Technical Note

Project	Greenway Junior School	Project No	14500
Subject	Drainage Technical Note for Consented Scheme	Date	28 April 2026
File Ref	Drainage Technical Note for Consented Scheme.docx	Pages	4

This technical note has been produced with the intention of Discharging Condition 3 of the Planning application DC/22/1954 regarding the site located at Greenway Academy, Greenway, Horsham, RH12 2JS.

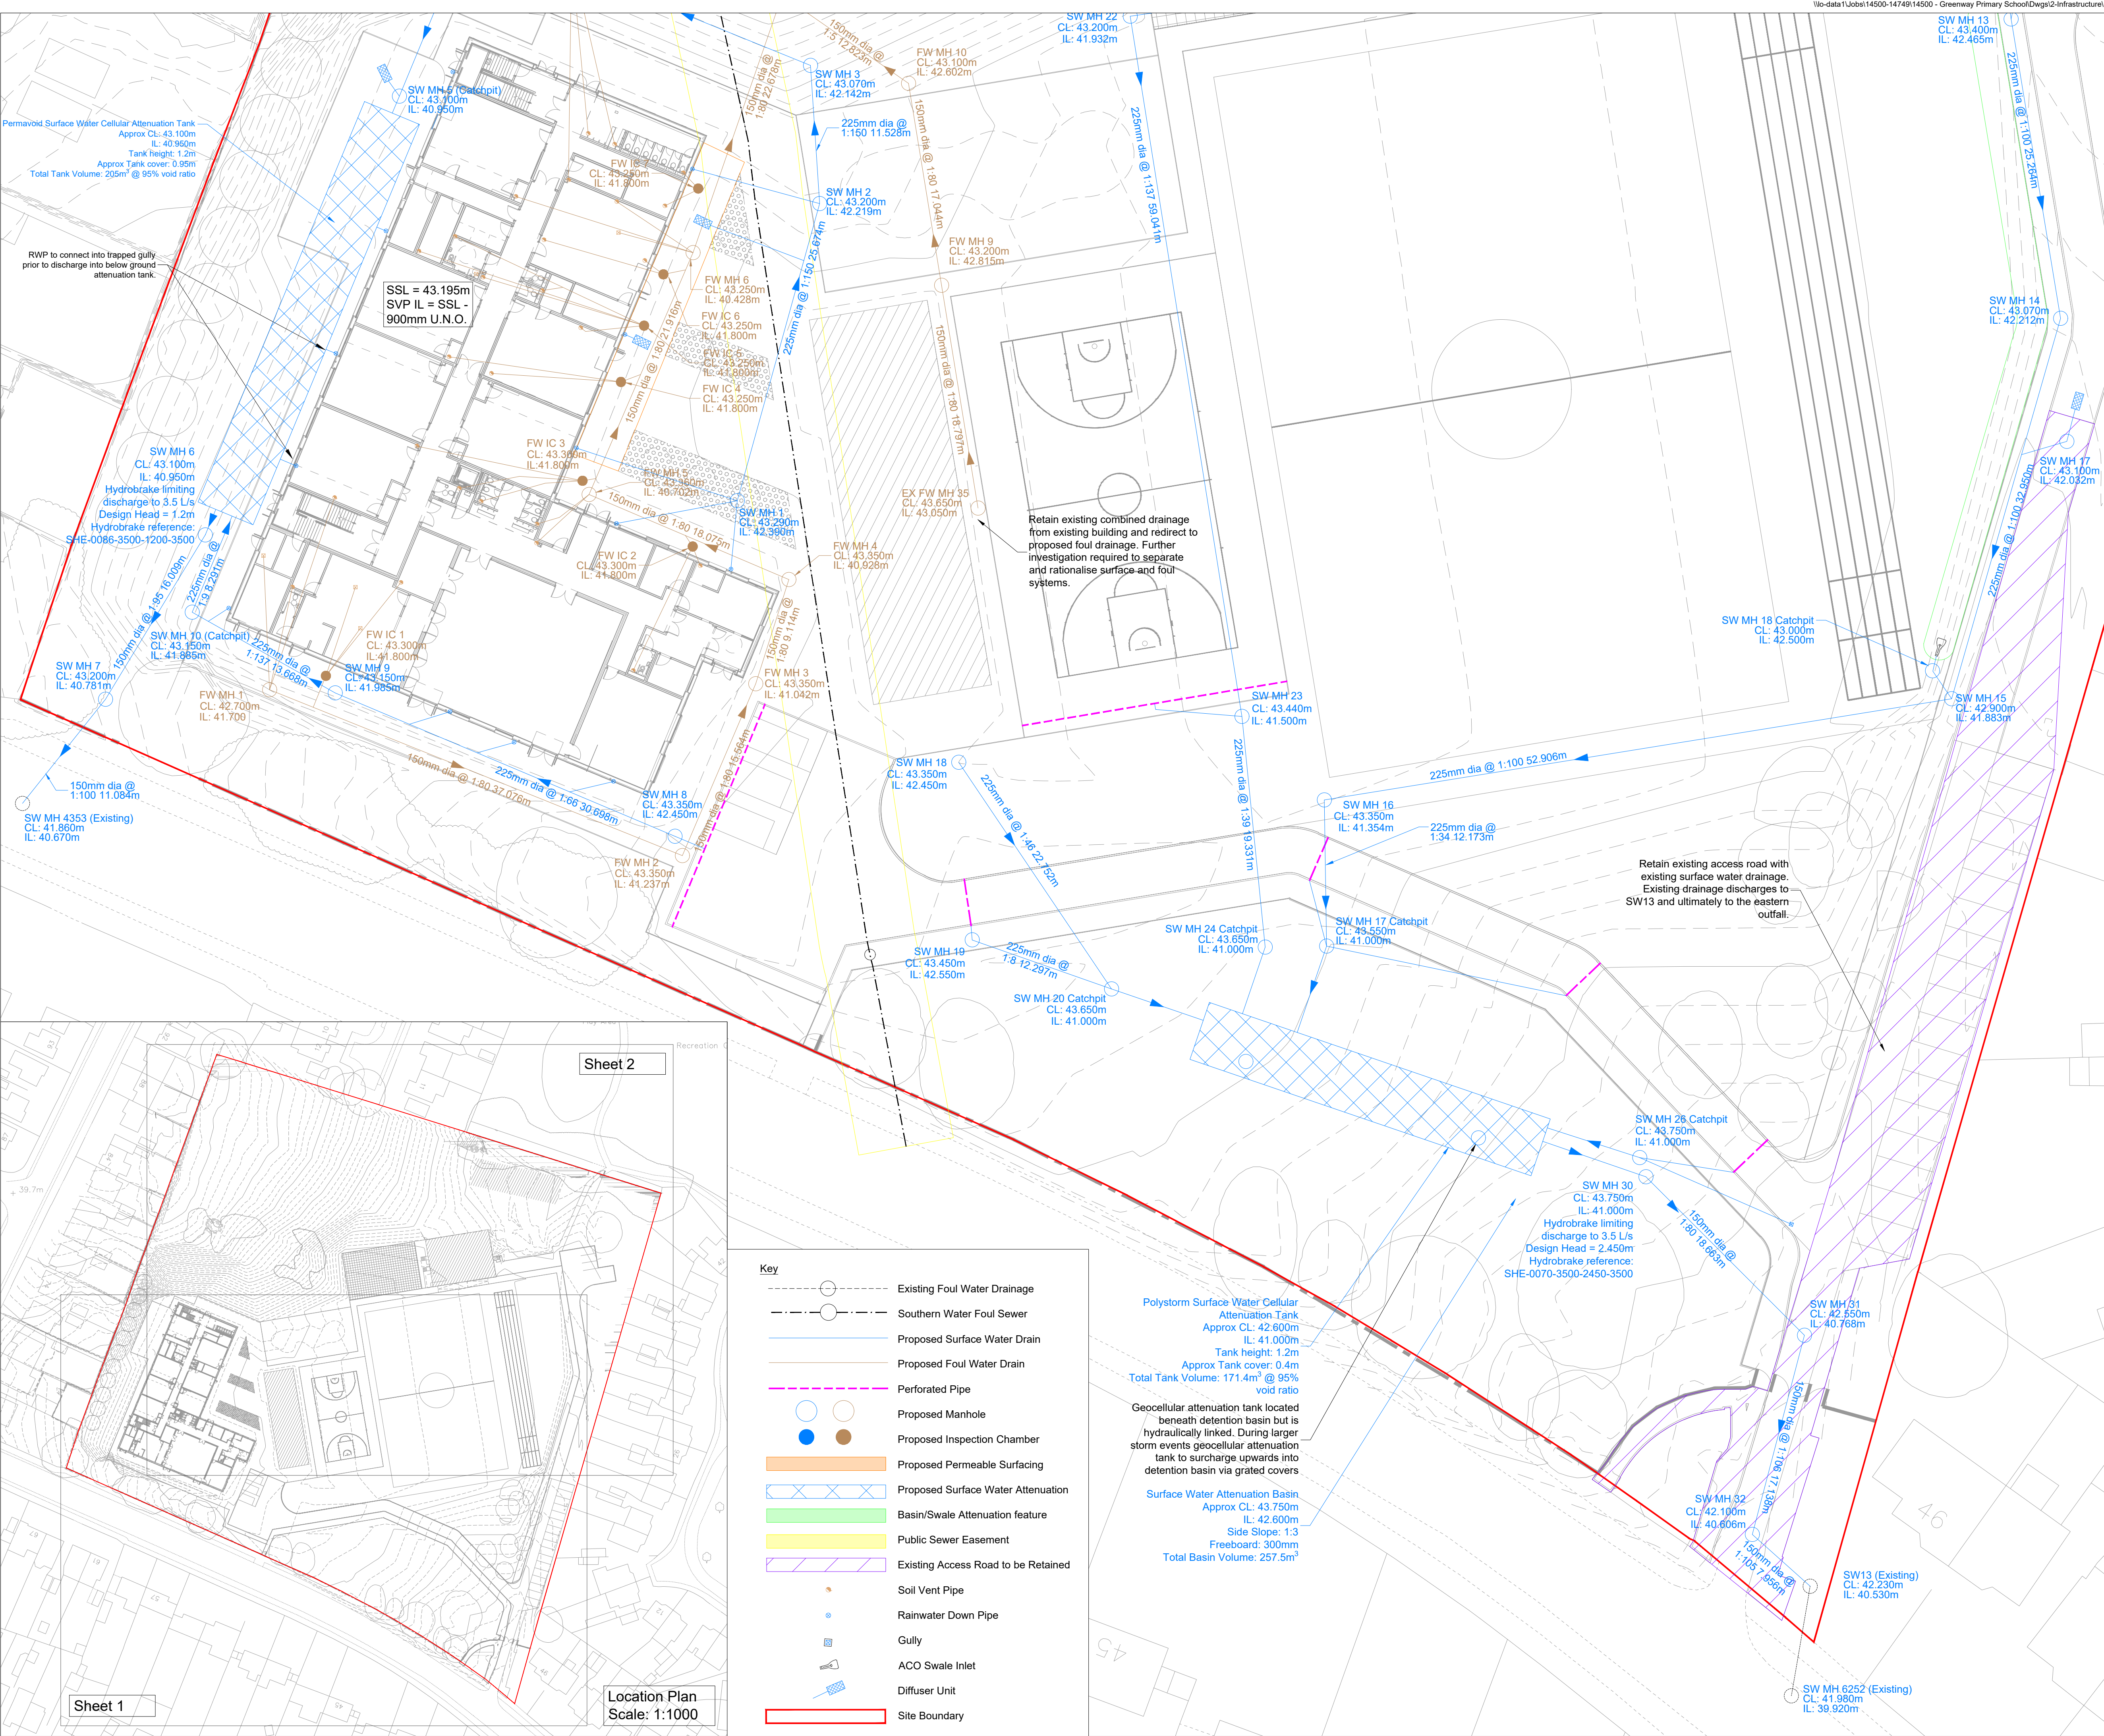
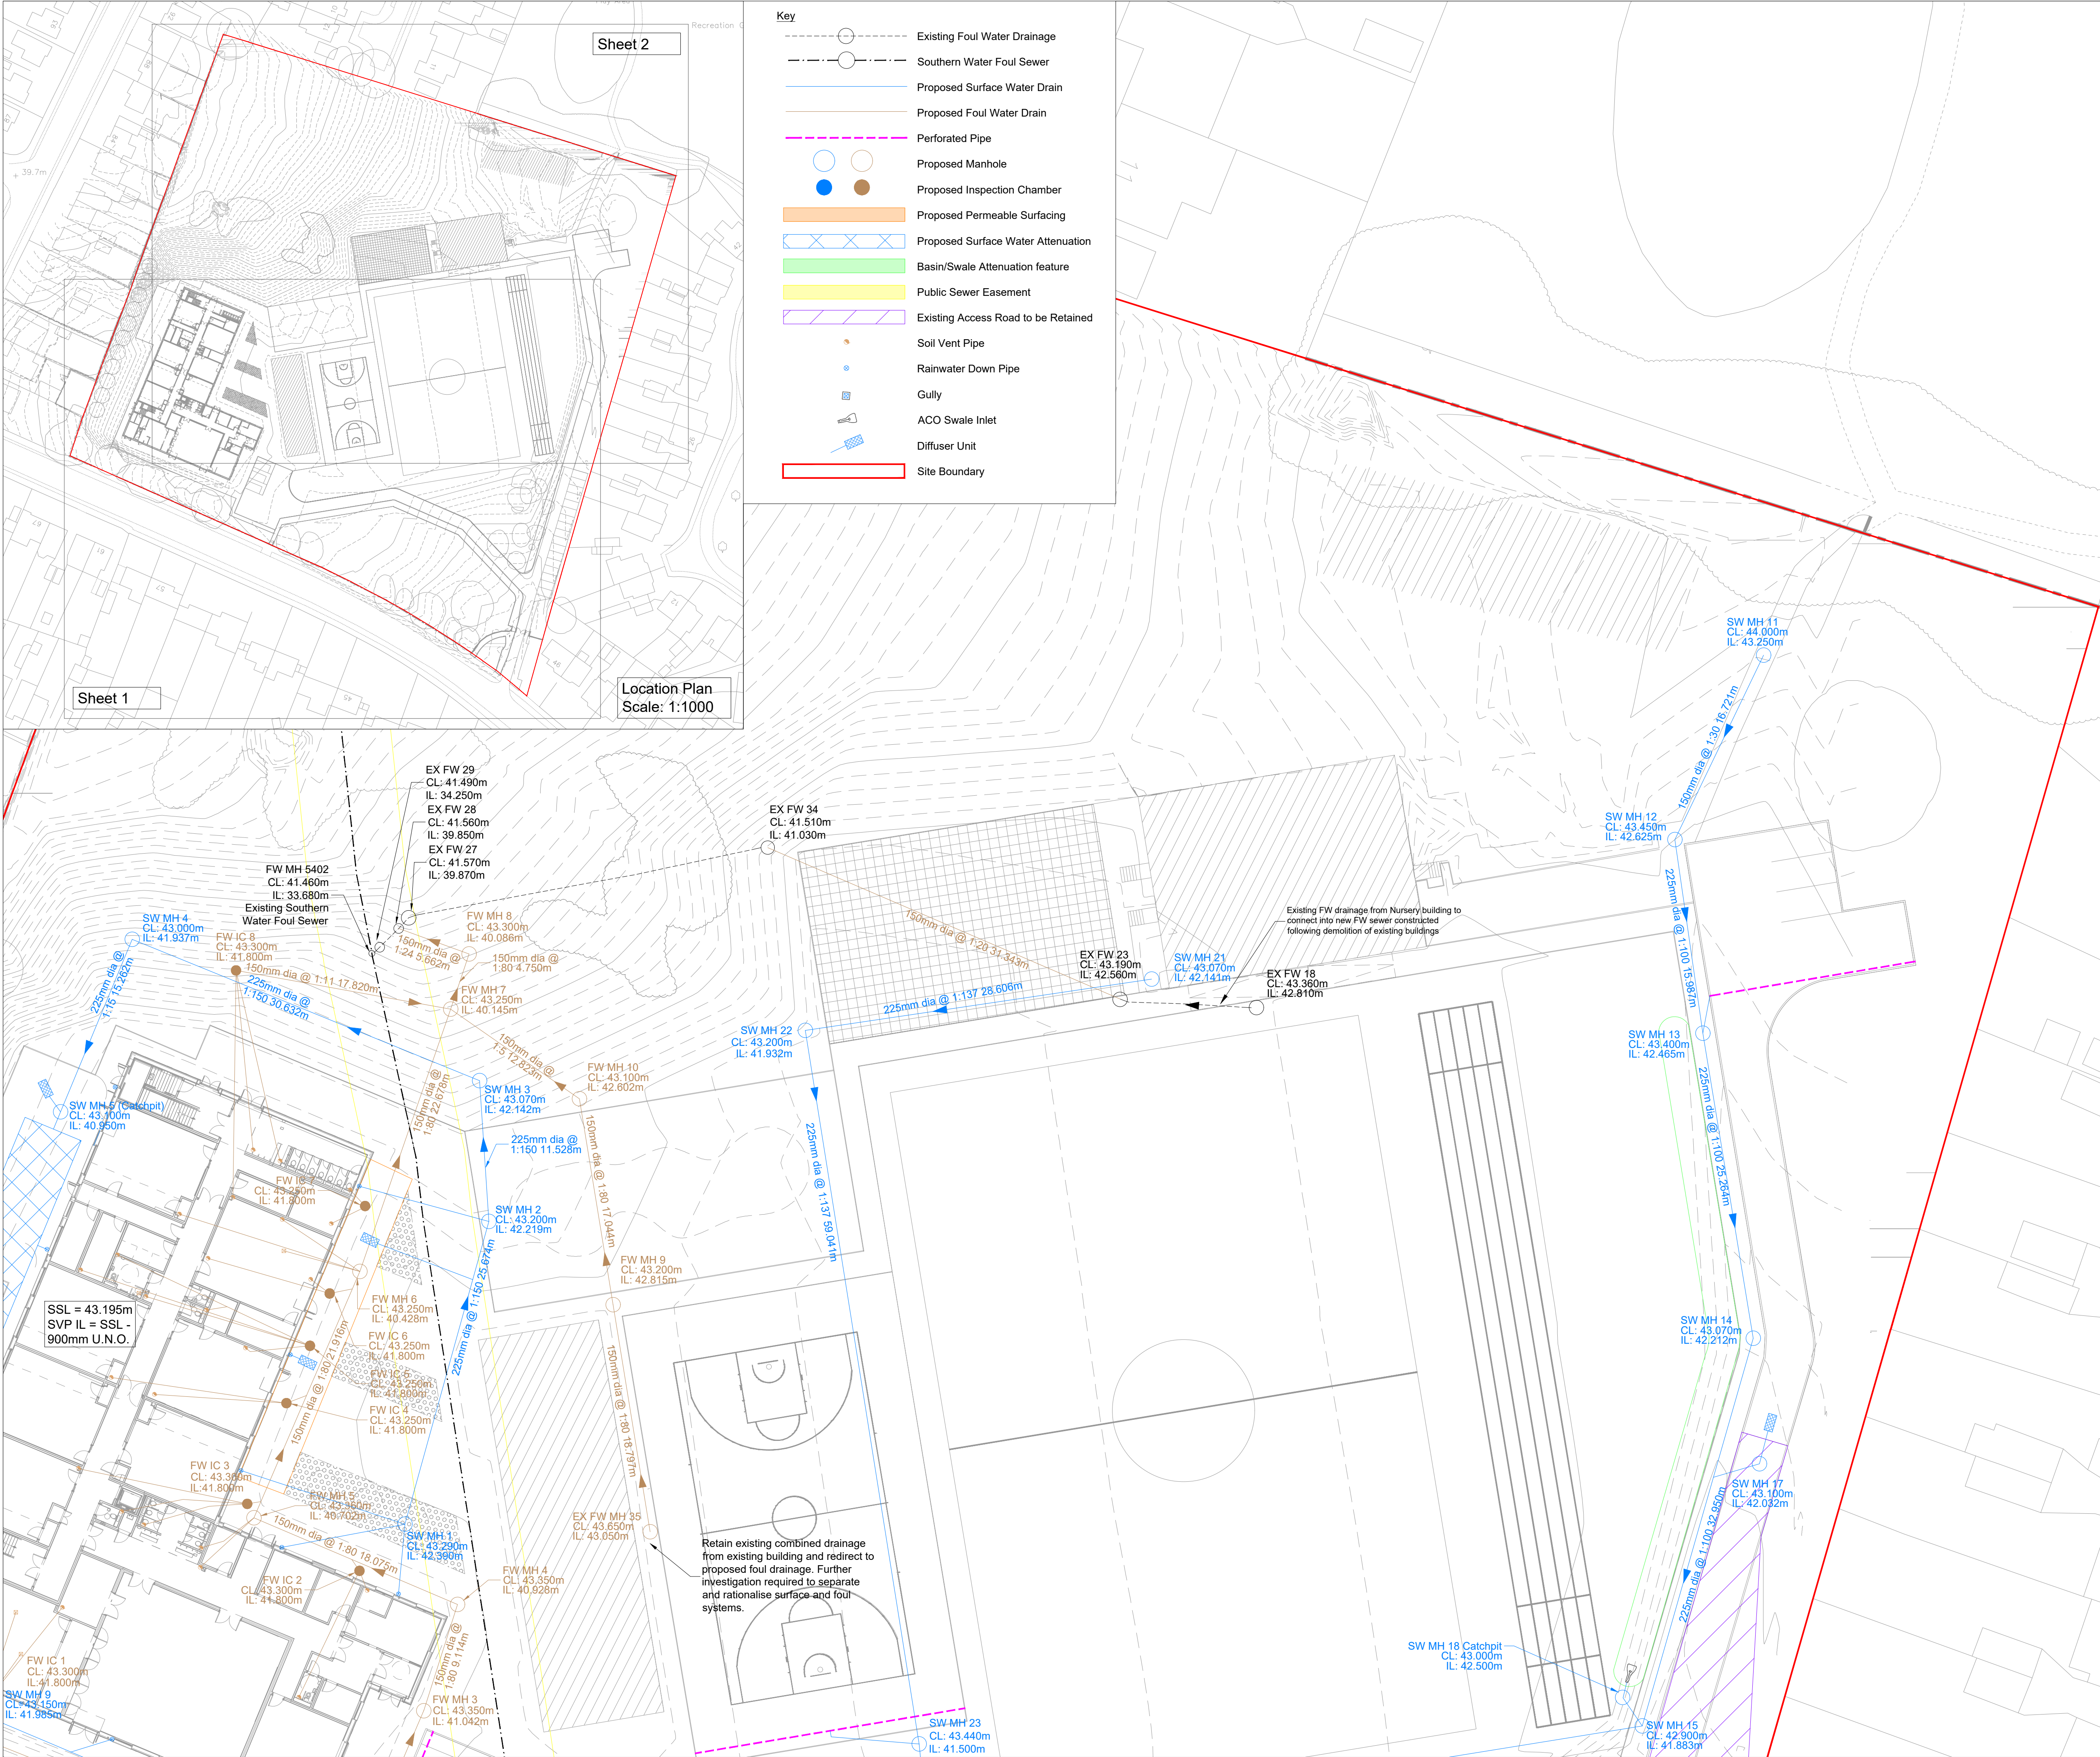
5. The labels on the drainage strategy must match the calculations. The drainage layout has been updated since 2023, but the date hasn't been updated.

6. For the attenuation tank, there is 500mm of cover for the attenuation tank. In the Drainage Strategy dated 13th March 2023, Figure 4 shows minimum cover must be 1000mm.

7. For ATT02 in the calculations, it has been designed with an infiltration depth, however in the drainage layout it is a tanked feature.

8. An exceedance plan for the proposed drainage strategy is required, to ensure routes are not towards buildings and property.

9. It is disappointing to see a traditional end of pipe design being used. SuDS should be designed to have multifunctional benefits. The current design does not meet the 4 pillars (water quality, water quantity, amenity, biodiversity) of SuDS design. Whilst we appreciate this application is for a school, there are several examples of where SuDS are used in schools.

The labels within the drainage strategy matches the calculations within the updated drainage strategy. The updated drainage strategy for the consented scheme has been based on the SRP1029-MAC-XX-XX-D-L-0007 by MAC Consulting Ltd dated 23/05/2023.

Within the updated drainage strategy, there are two attenuation tanks, both of the attenuation tanks have been designed in accordance with the required cover as per the manufacturer requirements, for the loading anticipated.

Due to the ground condition on site, it is anticipated that infiltration would not be feasible on site. This is further confirmed by BRE365 testing conducted on 26/03/2026. The test results indicate little to no infiltration capacity within the location and depth of the proposed tanks. Therefore, infiltration is not proposed for this development.

Through a pre-application meeting held on the 20th April 2026, the LLFA has been consulted on the consented scheme. During the meeting, the LLFA has confirmed that an exceedance plan is not necessary or required on this occasion, and therefore this has not been provided to discharge Condition 3. The general levels strategy would in all cases allow for surface water to drain away from buildings, follow the general circulation pathways around the site towards lower elevations to the south and ultimately into Greenway and the associated highway drainage network.

With consideration of the above feedback, the updated drainage strategy has considered the 4 pillars of SuDS design within the proposal. The general drainage strategy has been laid out below.

The surface water catchment has been analysed and the Greenfield runoff rate (Q_{bar}) calculated. The proposed discharge rates for the development should be restricted to Q_{bar} at 7L/s based on 1.85ha of catchment area contributing to the surface water drainage system. The proposed discharge rate will be split across two separate surface water drainage networks which will both ultimately discharge into public surface water sewers beneath Greenway road at 3.5L/s and 3.5L/s for the eastern and western outfalls respectively for all storm events up to and including the 1 in 100year plus CC event.

Permeable pavement systems are to be installed where possible around the proposed building, within the carpark and MUGA, to provide interception and treatment of surface water runoff. The subbase beneath permeable pavements will also be used to attenuate flows at source which will allow the size of the downstream attenuation tanks to be optimised during detailed design.

A swale system has also been implemented further upstream within the eastern network to capture runoff from the site access road, this in turn will help to reduce peak discharge rates and improve the water quality prior to entering the main below ground drainage system.

Two separate attenuation tanks have been proposed for this site, one for each outfall. The tank on the west side of the site sits immediately adjacent to the proposed building on its northwestern edge and discharges into Southern Water Manhole 4253 via a flow control manhole located immediately downstream of the tank.

The eastern attenuation tank is located immediately beneath a proposed dry detention basin which is hydraulically linked to the underlying tank. During larger storm events the tank will surcharge upwards and begin to fill the basin. This has allowed the size of the underlying tank to be kept to a minimum with any additional storage requirements being provided in the above ground basin. The inclusion of the basin adds further amenity and biodiversity benefit to the SuDS scheme proposed for the site as it will also provide water quality improvements as well as providing interception for any runoff which enters the basin directly from any adjacent impermeable areas. The flow control manhole ref SW MH 30 located downstream of the south-eastern attenuation tank is then connected to an existing surface water demarcation chamber which discharges ultimately to the Southern Water Manhole 6252.

The updated drainage strategy has considered water quality, amenity, and biodiversity benefits within its SuDS design by incorporating permeable paving, a swale, and a detention basin within its proposal.
